# CITY OF PORTLAND, OREGON

# Staff Presentation to the **Portland Design Commission**

# EA 15-269535 DA Bridge Housing / Riverplace Parcel 3

### **Adjustment**

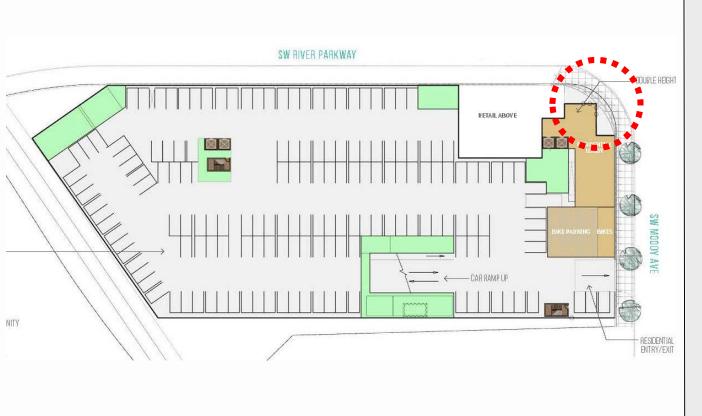
Allow parking access from SW River Parkway via a driveway extending south from the intersection of River Parkway and SW River Dr, and allow parking right-in, right-out parking access from SW Moody Ave
